UNITED STATES PATENT AND TRADEMARK OFFICE

APPLICATION NO.	FILING DATE	FIRST NAMED INVENTOR	ATTORNEY DOCKET NO.	CONFIRMATION NO.
10/752,284	01/05/2004	Yeung Kai Wah Mason	260-003	3411

Office Action Summary	Application No. 10/752,284	Applicant(s) MASON, YEUNG KAI WAH	
	Examiner Philip Gabler	Art Unit 3637

DETAILED ACTION

Exhibit 1: Monneret '573 Figures 1 and 2

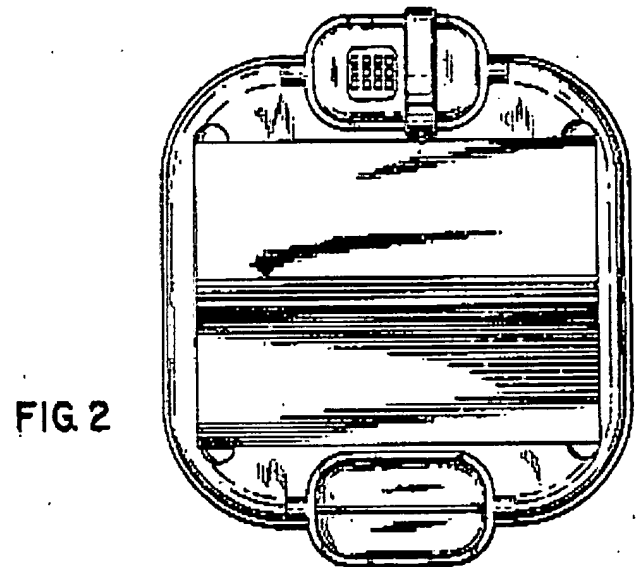
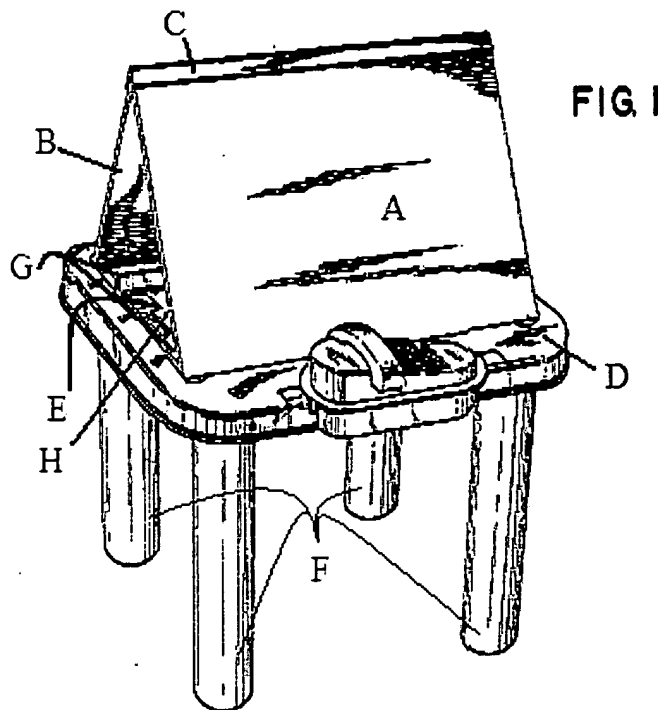
14. Claims 17, 21, 22, 26, 32, and 33 are rejected under 35 U.S.C. 102(b) as being anticipated by Monneret (US Patent Number D330573). Monneret (Figures 1 and 2) discloses a desk comprising an upper surface (viewed as A and B in Exhibit 1), wherein said upper surface is further comprised of a first surface (A) made of a first material and having a first edge, a second edge, a third edge and a fourth edge, a second surface (B) made of a second material (the first and second materials are not specifically

disclosed, and may or may not be the same material) and having a first edge, a second edge, a third edge and a fourth edge, wherein said first edge of first surface being attached to said first edge of said second surface by a hinged mechanism (C); a frame (D) comprised of a rectangular surface having a substantially rectangular concentric hole (E), top, bottom, a first inner edge, first outer edge, second inner edge, second outer edge, third inner edge, third outer edge, fourth inner edge and fourth outer edge; four support members (F), wherein each said support member has a first and a second end and each said first end of each said member is in contact with the ground and each said second end of each said member is in contact with said frame; and at least two cross members (rails under unhinged edges of surfaces seen in Figure 1, G), each of said members having a first end, a second end, an inner surface, a top end and a bottom end, wherein each said first end and each said second end of each said cross member is connected to said bottom of said frame and capable of supporting the weight of said upper surface.

15. Regarding claim 21, Monneret further discloses said at least two cross members are positioned substantially parallel with each other and with said second inner edge.

16. Regarding claim 22, Monneret further discloses said support members connect to said bottom of said frame near the intersection of two connecting inner edges of said frame.

17. Regarding claim 26, Monneret further discloses a lower surface (H) attached to the bottom end of each cross member to provide a storage compartment contained within said frame and covered by said upper surface.

18. Regarding claims 32 and 33, Monneret further discloses said four support members are connected perpendicularly to said frame (and accordingly at an angle between 90 and 145 degrees).

Tsai '939 Figures 2, 4, 13, and 17

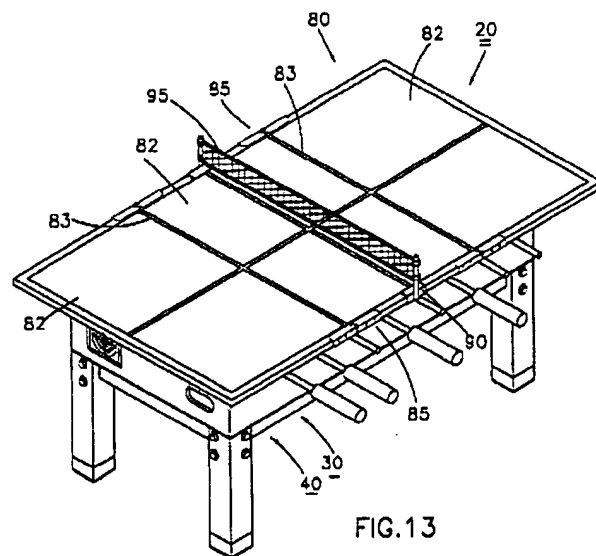
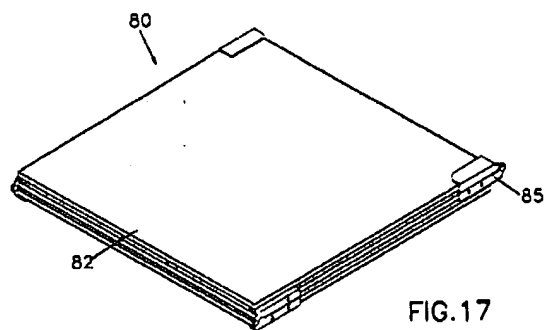
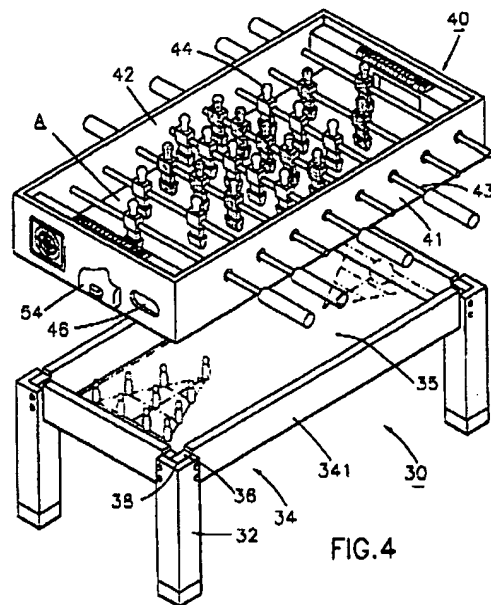
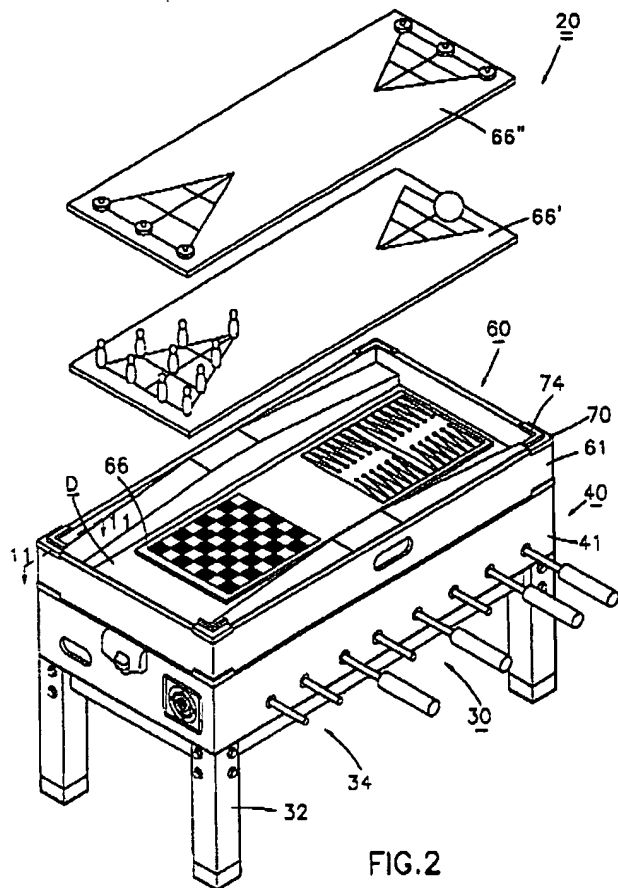
20. Regarding claims 17 and 34, Tsai (Figures 2, 4, 13, and 17) discloses a table usable as a desk comprising an upper surface (80), wherein said upper surface is further comprised of a first surface (leftmost element 82 as seen in Figure 13) made of a first material and having a first edge, a second edge, a third edge and a fourth edge, a

second surface (rightmost element 82 as seen in Figure 13) made of a second material (the first and second materials are not specifically disclosed, and may or may not be the same material) and having a first edge, a second edge, a third edge and a fourth edge, wherein said first edge of first surface being attached to said first edge of said second surface by a hinged mechanism (middle element 82 as well as elements 85); a frame (of elements 40, 60) comprised of a rectangular surface having a substantially rectangular concentric hole (in the center of the assembly, formed by the walls of 40, 60), top, bottom, a first inner edge, first outer edge, second inner edge, second outer edge, third inner edge, third outer edge, fourth inner edge and fourth outer edge; four support members (32), wherein each said support member has a first and a second end and each said first end of each said member is in contact with the ground and each said second end of each said member is in contact with said frame; at least one storage tray (viewed as the lower horizontal surface of 40) removably contained below said frame; and at least two cross members (two rails formed on the inside of element 60, see Figure 2), each of said members having a first end, a second end, an inner surface, a top end and a bottom end, wherein each said first end and each said second end of each said cross member is connected to said bottom of said frame and capable of supporting the weight of said upper surface.

21. Regarding claim 21, Tsai further discloses said at least two cross members are positioned substantially parallel with each other and with said second inner edge.

22. Regarding claim 22, Tsai further discloses said support members connect to said bottom of said frame near the intersection of two connecting inner edges of said frame.

23. Regarding claims 23-25, Tsai further disclose decorative and gameboard designs (57, 66, lines on 80, etc.) on the frame and upper surface.

24. Regarding claim 26, Tsai further discloses a lower surface (lower horizontal surface of 40) attached to said bottom of said frame to provide a storage compartment contained within said frame and covered by said upper surface.

25. Regarding claim 27, Tsai further discloses at least one additional support member (341) having a first end and a second end, wherein said first end is connected to one of said four support members and said second end is connected to another of said four support members.

26. Regarding claim 30, Tsai further discloses at least one storage tray (viewed as the lower horizontal surface of 40) removably contained below said frame.

27. Regarding claims 32 and 33, Tsai further discloses said four support members are connected perpendicularly to said frame (and accordingly at an angle between 90 and 145 degrees).

Benlian '611 Figure 1

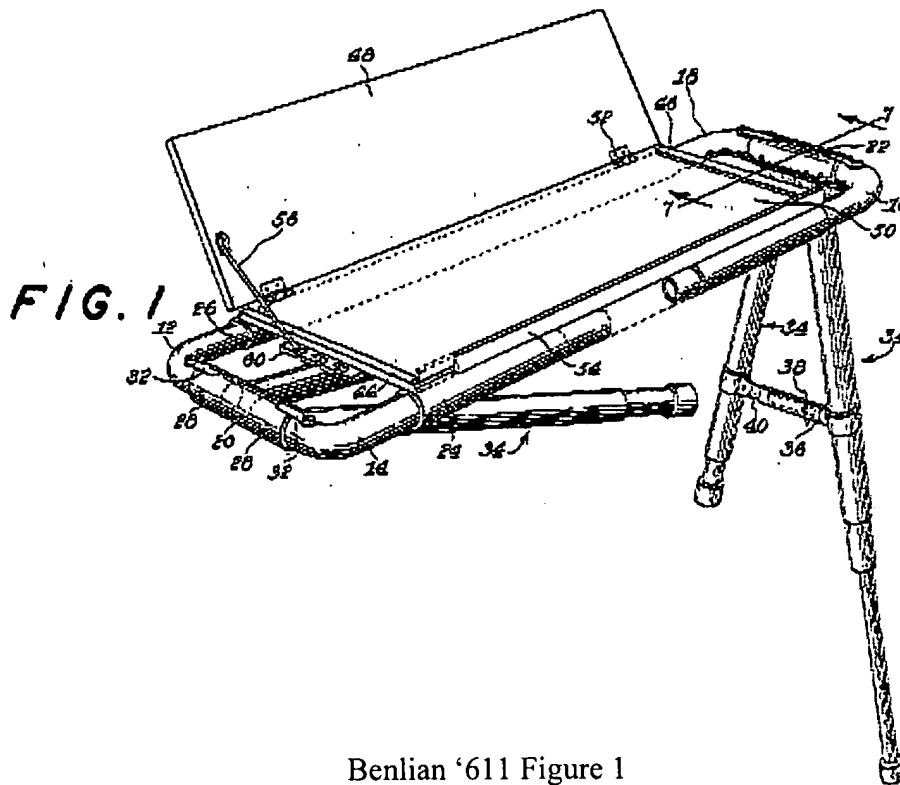
28. Claims 17, 21, 22, 28, 29, 32, and 33 are rejected under 35 U.S.C. 102(b) as being anticipated by Benlian (US Patent Number 3246611). Benlian (Figure 1) discloses a desk comprising an upper surface (48, 50), wherein said upper surface is

further comprised of a first surface (48) made of a first material and having a first edge, a second edge, a third edge and a fourth edge, a second surface (50) made of a second material (the first and second materials are not specifically disclosed, and may or may not be the same material) and having a first edge, a second edge, a third edge and a fourth edge, wherein said first edge of first surface being attached to said first edge of said second surface by a hinged mechanism (at 52); a frame (12, 14, 16, 18, 20, 22, etc.) comprised of a rectangular surface having a substantially rectangular concentric hole (formed by the frame members), top, bottom, a first inner edge, first outer edge, second inner edge, second outer edge, third inner edge, third outer edge, fourth inner edge and fourth outer edge; four support members (34), wherein each said support member has a first and a second end and each said first end of each said member is in contact with the ground and each said second end of each said member is in contact with said frame; and at least two cross members (44, 46), each of said members having a first end, a second end, an inner surface, a top end and a bottom end, wherein each said first end and each said second end of each said cross member is connected to said bottom of said frame (via members 24, 26) and capable of supporting the weight of said upper surface.

29. Regarding claim 21, Benlian further discloses said at least two cross members are positioned substantially parallel with each other and with said second inner edge.

30. Regarding claim 22, Benlian further discloses said support members connect to said bottom of said frame near the intersection of two connecting inner edges of said frame.

31. Regarding claim 28, Benlian further discloses each of said four support members is hingedly attached to said frame.

32. Regarding claim 29, Benlian further discloses said second inner edge of said frame and fourth inner edge of said frame have a recessed opening (outside of members 44 and 46) protruding through both said top and bottom of said frame.

33. Regarding claims 32 and 33, Benlian further discloses said four support members are connected perpendicularly (at least in one plane) to said frame (and accordingly at an angle between 90 and 145 degrees).

Hackwood '271 Figure 2

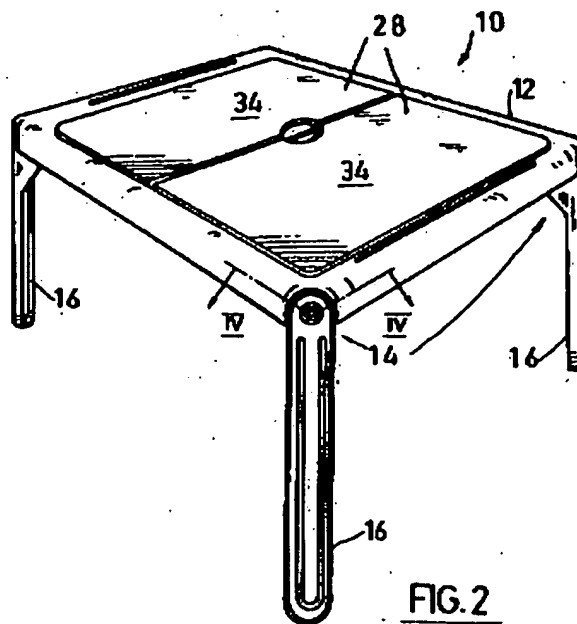
35. Claims 18 and 19 are rejected under 35 U.S.C. 103(a) as being unpatentable over Benlian in view of Hackwood et al. (US Patent Number 5244271). Benlian discloses a desk as recited in claim 17 but does not disclose a material for his first and second surfaces. Hackwood (Figure 2) discloses a desk with first and second surfaces (28) selected from the group consisting of blackboard, whiteboard, slate, dry erase or corkboard (specifically blackboard and whiteboard, see column 5 lines 4-11). Accordingly, it would have been obvious to one of ordinary skill in the art at the time the invention was made to use blackboard or whiteboard for Benlian's first and second surfaces as taught by Hackwood because this would allow the surfaces of the desk to be used for writing and conveying information directly.

Cheng '929 Figure 5

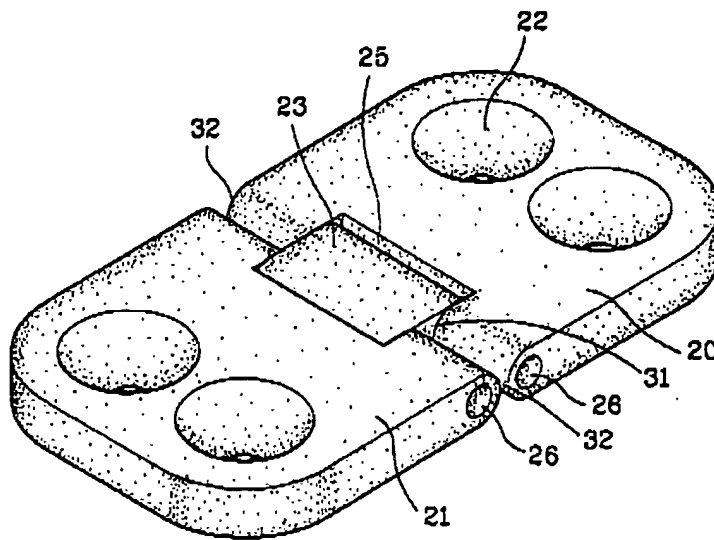
36. Claim 20 is rejected under 35 U.S.C. 103(a) as being unpatentable over Monneret in view of Cheng (US Patent Number 5659929). Monneret discloses a desk as recited in claim 17 but does not disclose specifics of his hinge mechanism. Hinge mechanisms capable of 360 degree rotation are known in the art however, as shown by Cheng who (Figure 5) discloses such a mechanism. Accordingly, it would have been obvious to one of ordinary skill in the art at the time the invention was made to incorporate a hinge mechanism as taught by Cheng in Monneret's desk because it would allow a user to set the two surfaces at any angle relative to each other as desired.

Brenny '639 Figure 1 and 5

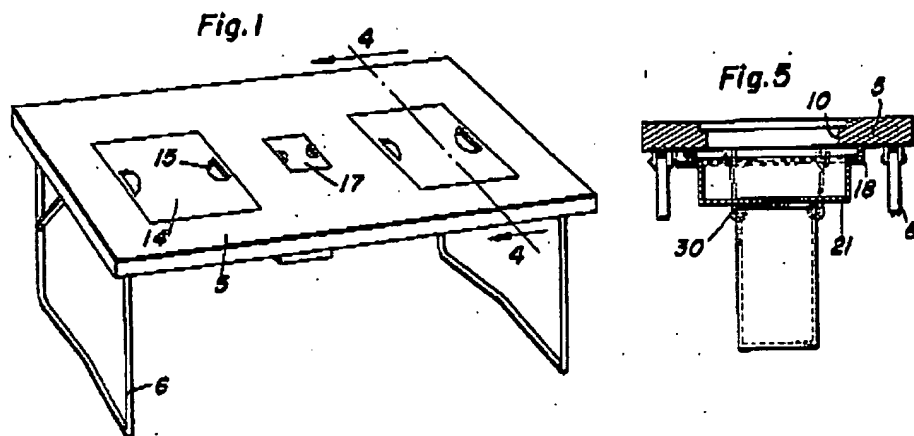
37. Claims 30 and 31 are rejected under 35 U.S.C. 103(a) as being unpatentable over Benlian in view of Brenny (US Patent Number 2683639). Benlian discloses a desk as recited in claim 17 including substantially parallel cross members, but does not disclose a storage tray below his frame. Brenny (Figures 1 and 5) discloses a table/desk including a storage tray (21) removably contained below a frame with substantially parallel cross members (opposite arms 18) comprising a protruding ridge (19) along inner surfaces which allow for the receipt of the at least one storage tray. Accordingly, it would have been obvious to one of ordinary skill in the art at the time the invention was made to include a storage tray as taught by Brenny in Benlian's desk because of the extra storage such a tray could provide.
